RECORD OF DECISION SUMMARY

NEW BEDFORD HARBOR/
HOT SPOT OPERABLE UNIT

APRIL 1990

U.S. ENVIRONMENTAL PROTECTION AGENCY
REGION I

FIGURE 1.1

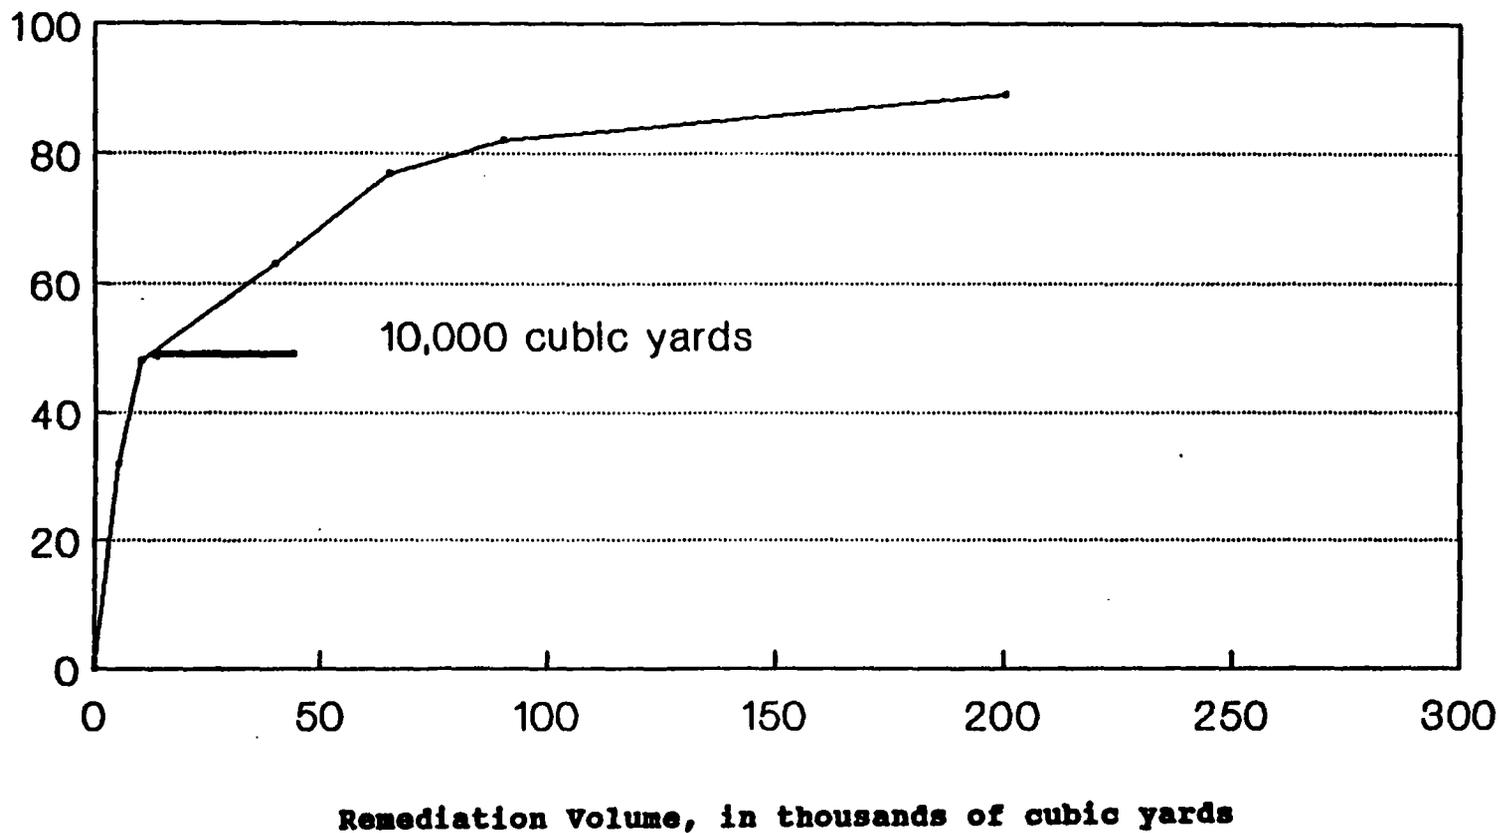
Figure 1.1 at the end of this Section depicts the relationship between the percentage of PCB mass and sediment volume in cubic yards for the Upper Estuary. As the number of cubic yards increases, the percentage of PCB mass per cubic yard decreases. The rate of change in the percentage of PCB mass as it relates to volume in cubic yards varies. At 4,000 ppm, or 48% PCB mass, the slope of the curve changes dramatically. Above this point, the rate of increase in percentage of PCB mass, as it relates to sediment volume, markedly diminishes. By using a target level of 4,000 ppm, EPA will remove the greatest percentage of PCB mass for the least volume of sediment. In EPA's judgment, removing sediment at 4,000 ppm and greater takes advantage of the steepest parts of the curve.

FIGURE 2.1

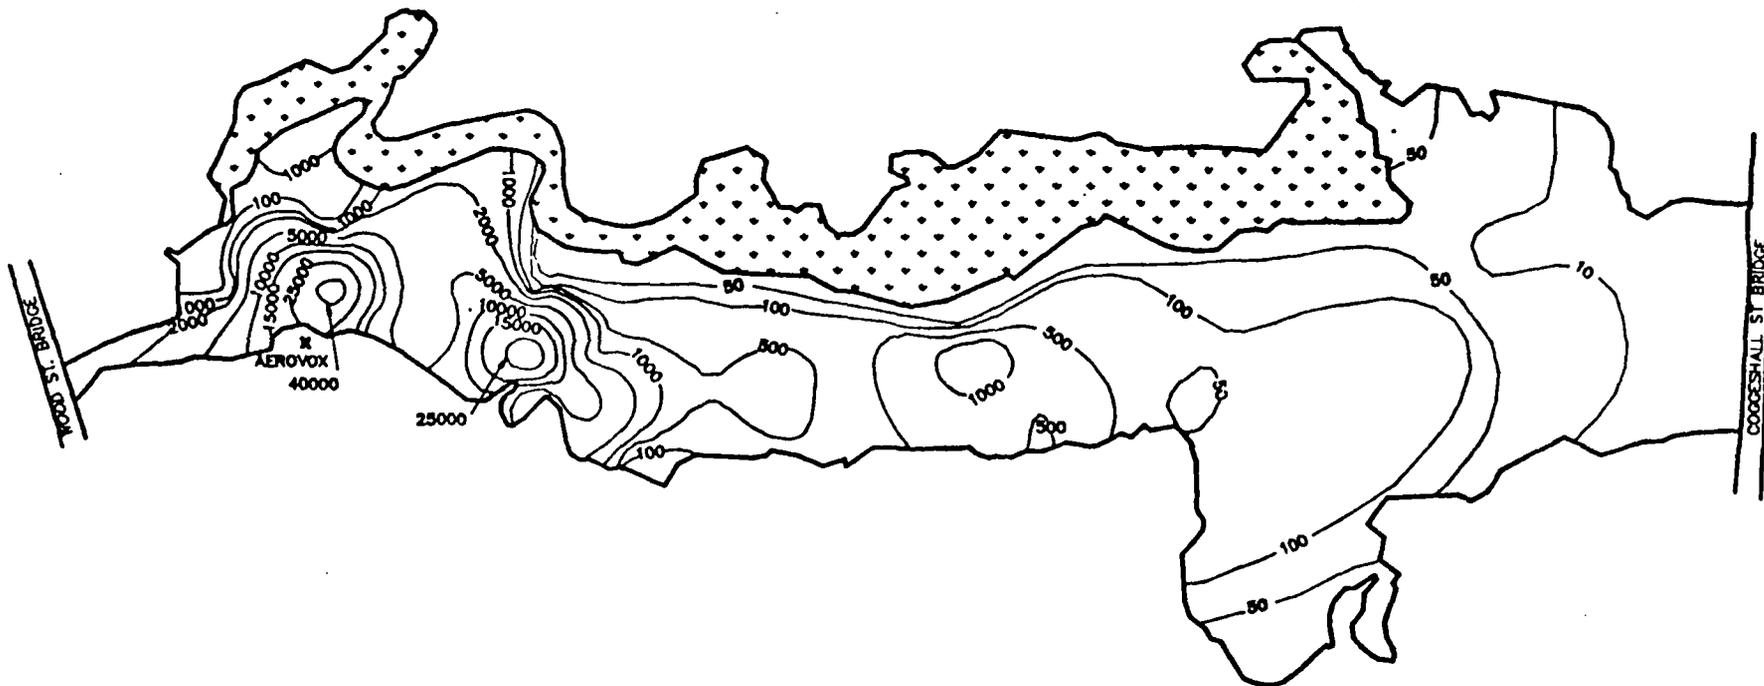
The PRPs' generated a contour map using EPA's data and it is presented in Figure 2.1 at the end of the Section. According to the PRPs, the kriging method produced results that, "represent reliable estimates of constituent masses and deposition in New Bedford Harbor upper Estuary sediment" (Balsam, 1989a). The PRP map (Figure 2.1) shows a similar extent of PCB contamination when compared to EPA's contour map (Figure 2.2). Both of these maps are validated by the PCB sediment sampling and analytical results from the thin layer sampling program conducted by the PRPs (Balsam, 1989b).

FIGURE 4-1

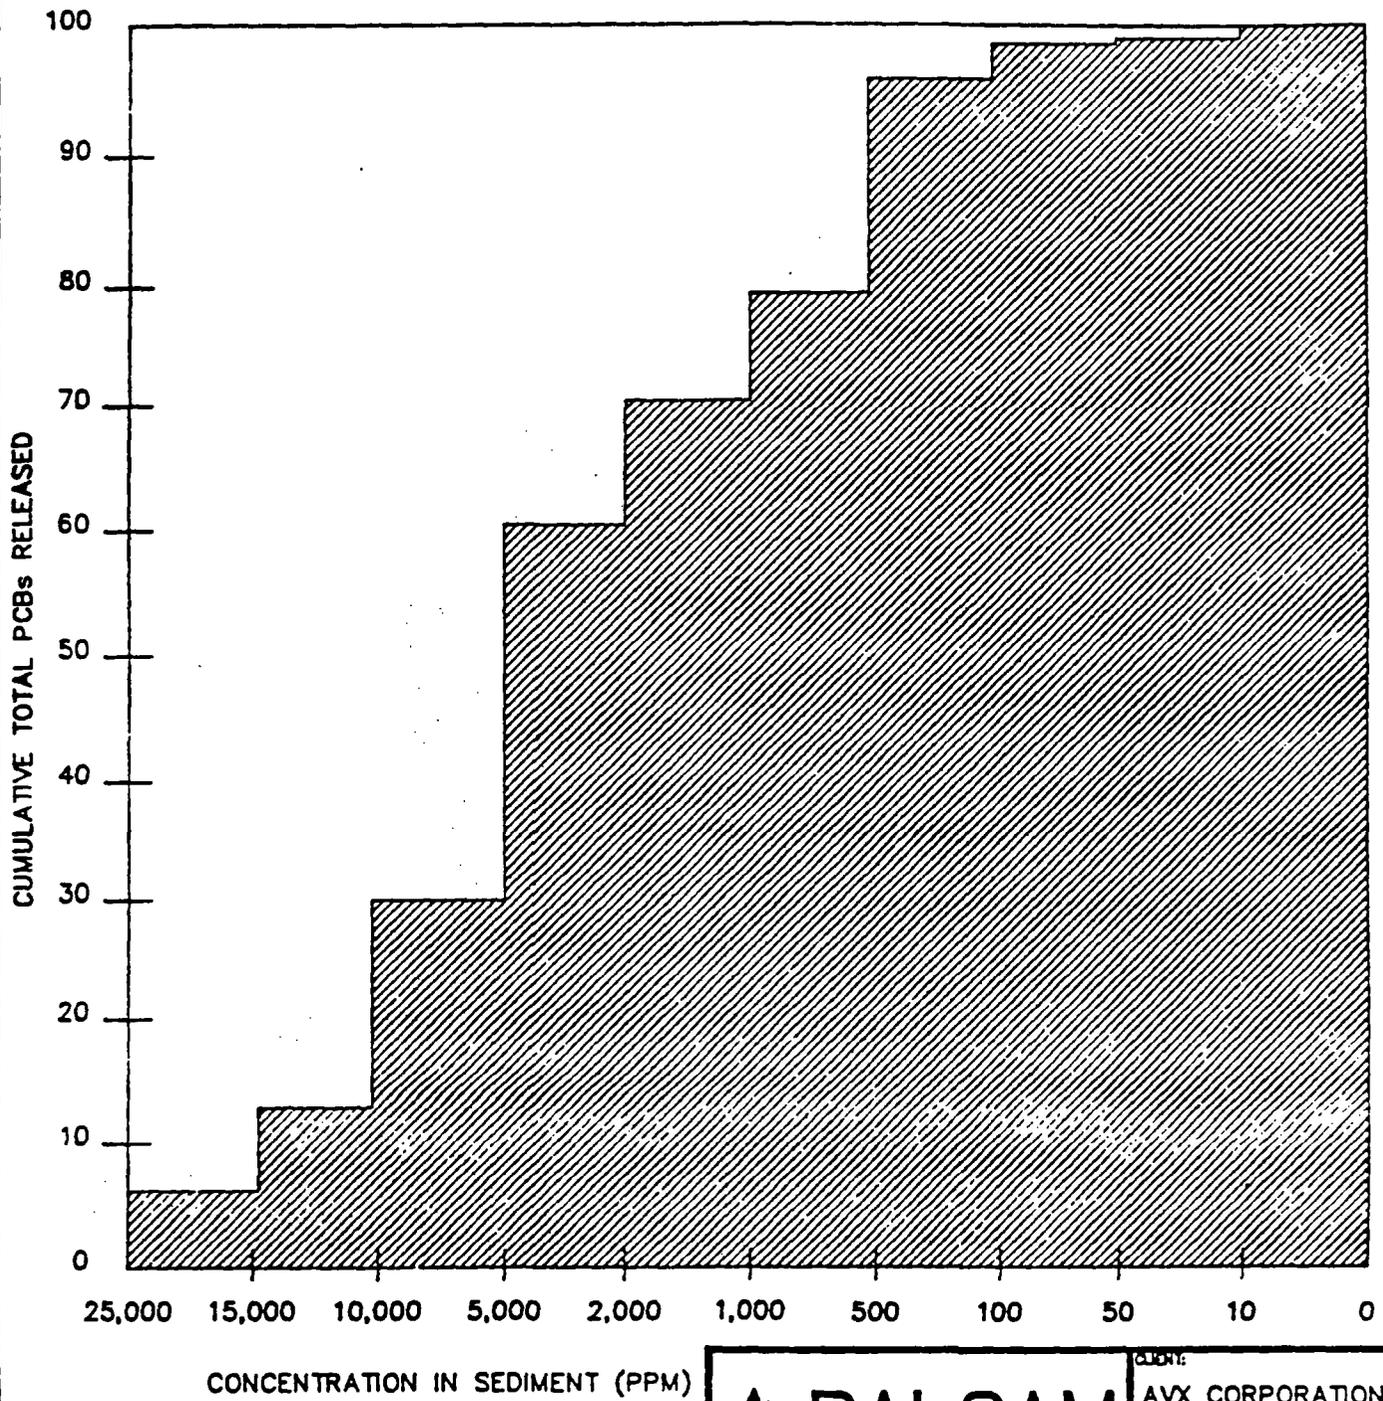
Further evidence of the important role of the Hot Spot is apparent in the flux modeling conducted by PRPs. This modeling estimates at least 30% of the total PCB flux is derived from the areas of contamination in excess of 4,000 ppm PCBs (i.e., the Hot Spot). Figure 4-1 at the end of this section illustrates this information.
